## TECHNICAL NOTE

Project: DM/25/2634 - Batchelors Farm, Keymer Road – Additional Traffic/Transport Information

STAGE 1 ROAD SAFETY AUDIT  
RESPONSE REPORT

**BACHELORS FARM, KEYMER ROAD  
BURGESS HILL  
S278 WORKS  
STAGE 1 ROAD SAFETY AUDIT**

Revision Details	By Check	Date	Suffix
Drawing Number	SK21799-07 REV A		
Batchelors Farm			
Drawing Title	Pedestrian Enhancements 120m Intervisibility Splays from Southern Crossing Tactile Paving		
Scale at A3	1:500		
Drawn	KAT	Approved MAK	
Check	KAT	Date 14/01/26

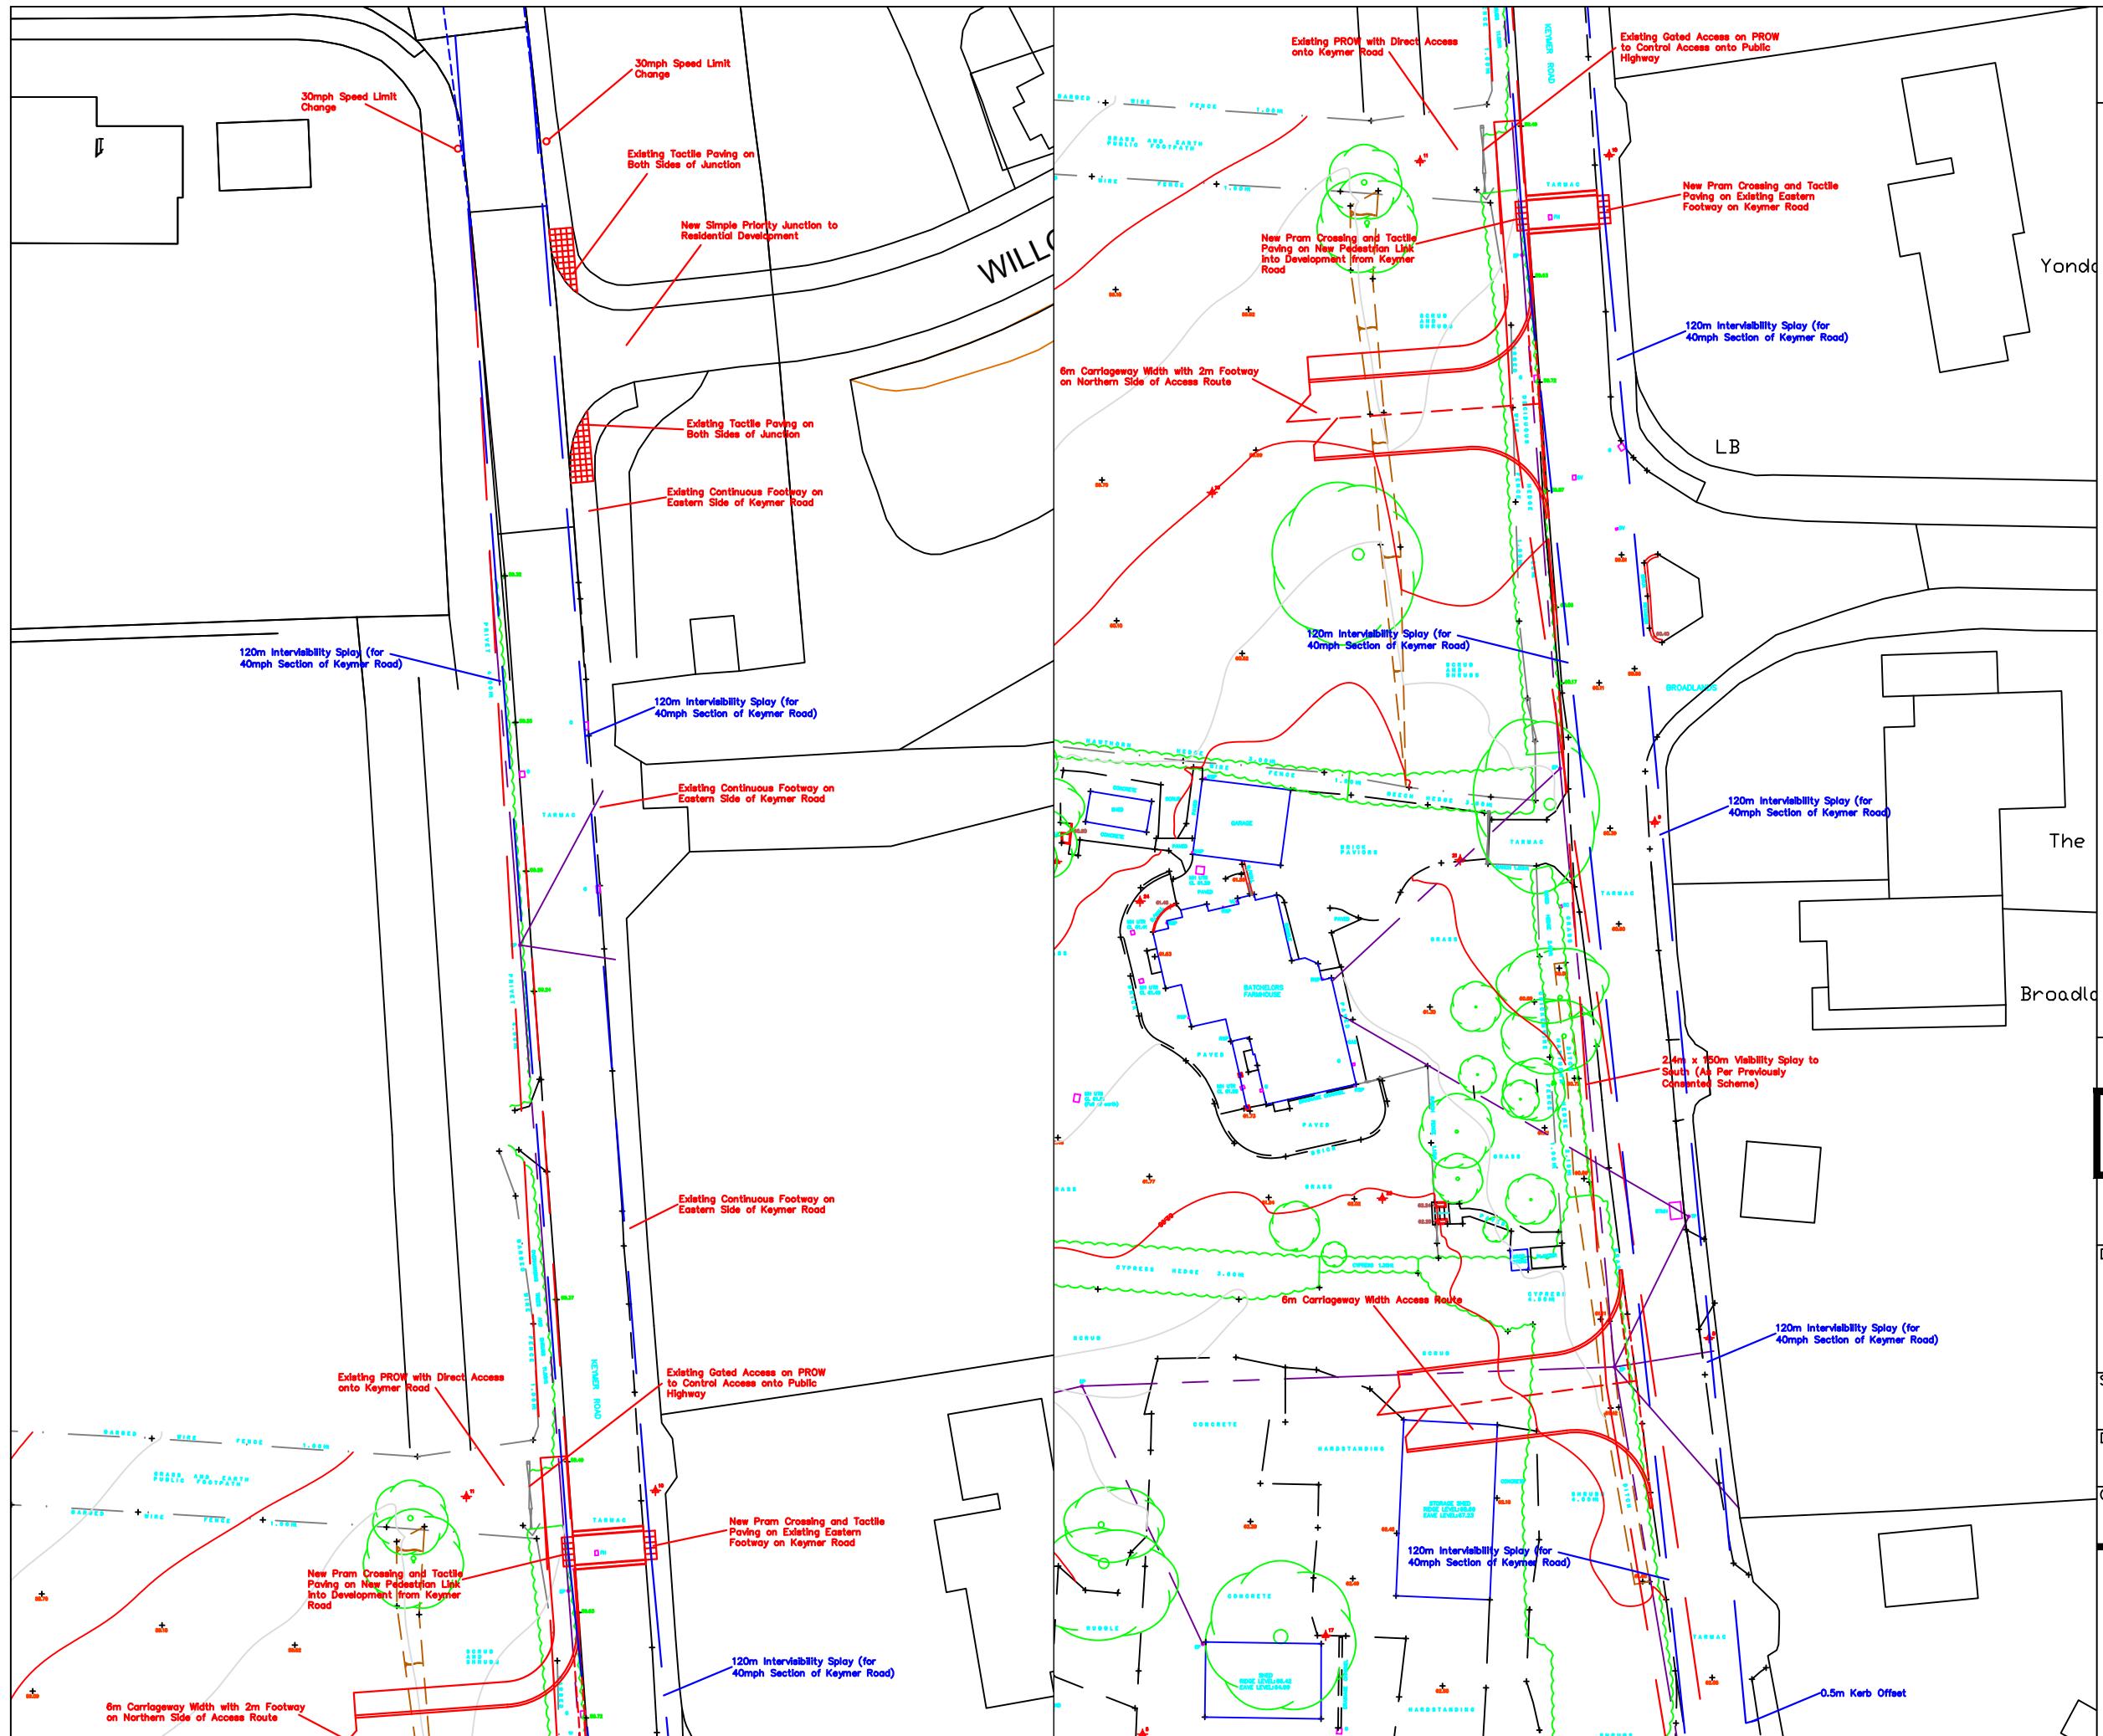
2.14 The RSA team has raised the concern that there is the potential for restricted inter-visibility between pedestrians crossing Keymer Road, particularly from west to east at the proposed northern and southern uncontrolled pedestrian crossing facilities and vehicular traffic on Keymer Road could lead to potential increased risks of vehicle/pedestrian collisions. This could result in pedestrians sustaining personal injury.

2.15 The RSA team has recommended that the intervisibility at the northern and southern uncontrolled pedestrian crossing facilities should be kept clear, by removing vegetation and street furniture (as required) to the rear of the footways. It is also recommended that the intervisibility distances should be provided on the scheme drawings.

2.16 In response to the RSA team's findings, we agree that appropriate levels of intervisibility should be provided between pedestrians standing on the tactile paving on the eastern and western sides of the crossing points, and the drivers/riders of vehicles using the Keymer Road.

2.17 The achievable intervisibility splays are shown on plan in **appendix d** at both crossing points, and can be secured in perpetuity through an appropriately worded Planning Condition.
